ENGINEER'S SUPPLEMENTAL INSTRUCTIONS NO. TWENTY-EIGHT (28)
(Via Posting to FTP Site and Electronic Mail)

RE: Harold D. Thompson Regional Water Reclamation Facility (HDTRWRF)-Phase 1
ENGINEER'S SUPPLEMENTAL INSTRUCTIONS TWENTY-EIGHT (ESI-28)

A PARTIAL VIEW — DISINFECTION EQUIPMENT AND PIPING PLAN

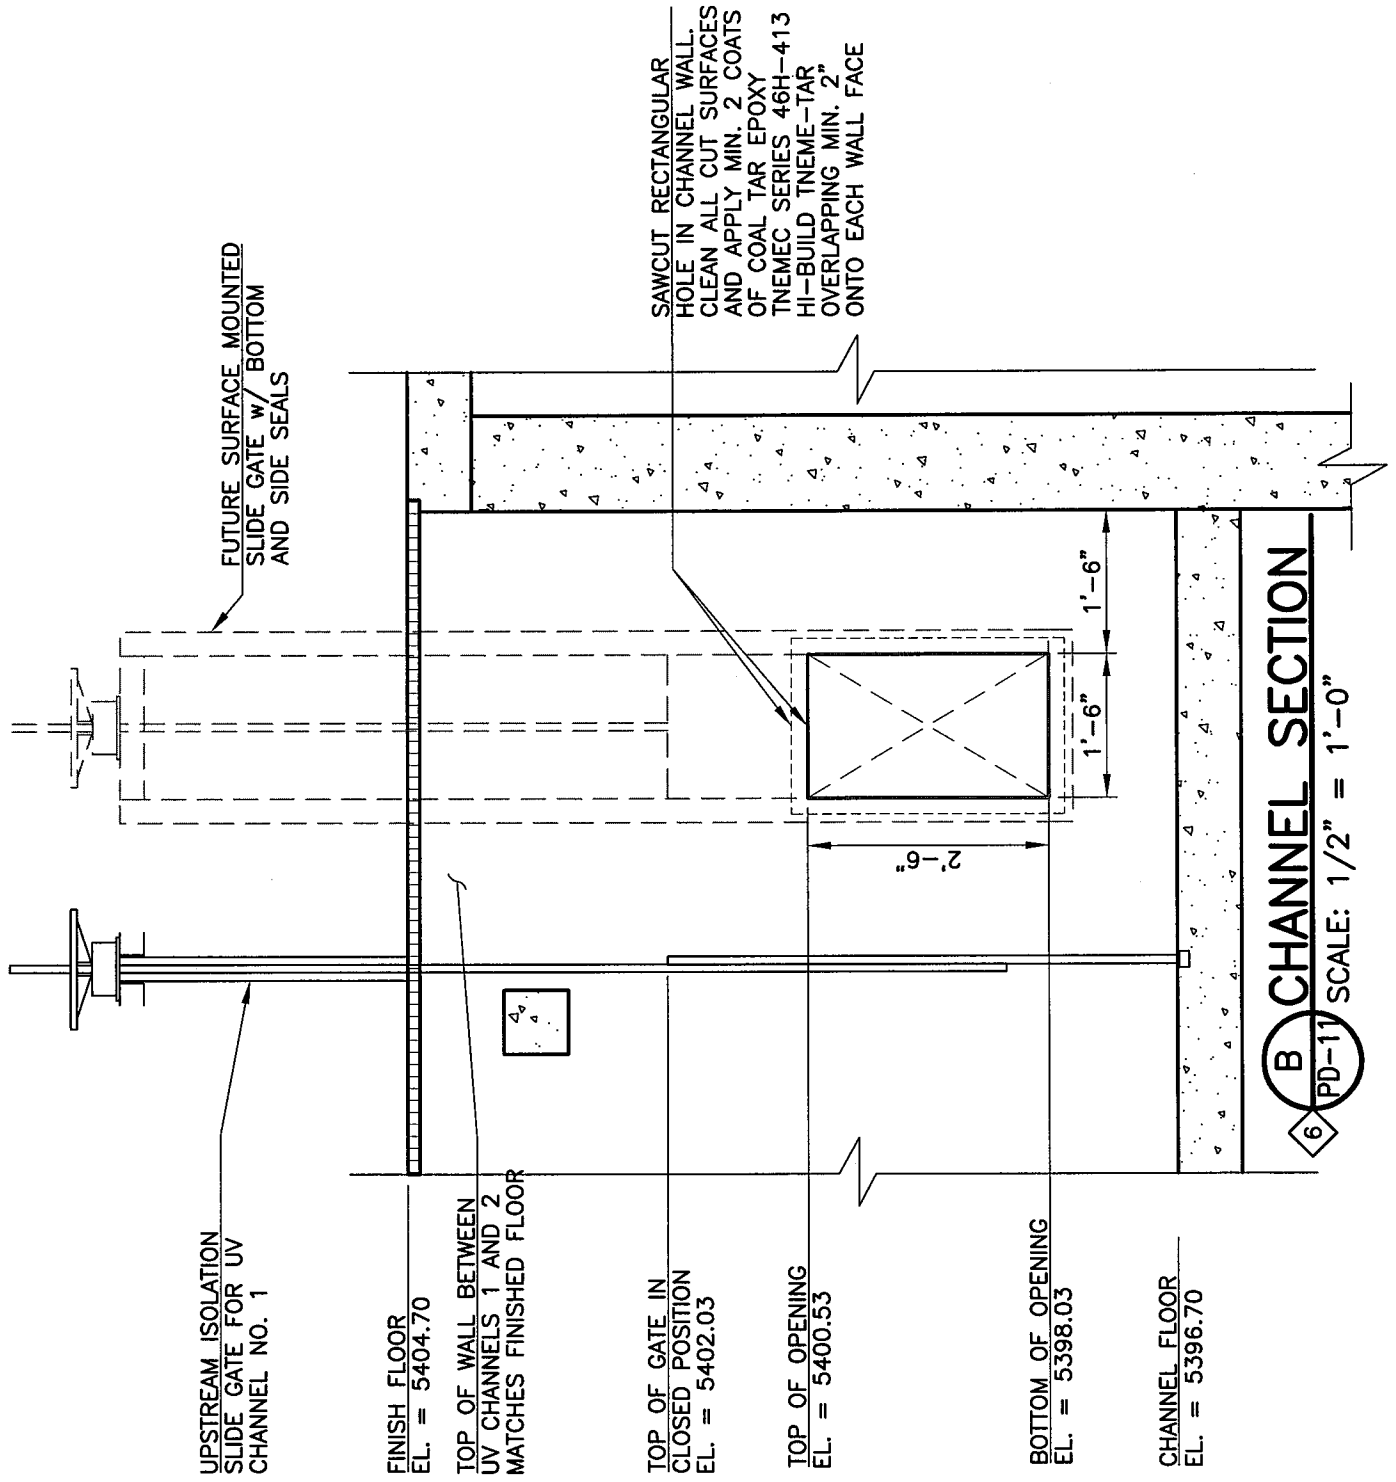
This ESI-028 provides information on work required in the UV disinfection channels to facilitate transfer of water between the two channels. The Drawings attached to this ESI-028 provide the installation details and construction requirements of the work. Refer to the list of attachments at the end of this ESI-028 for an itemization of those Drawings and Details.
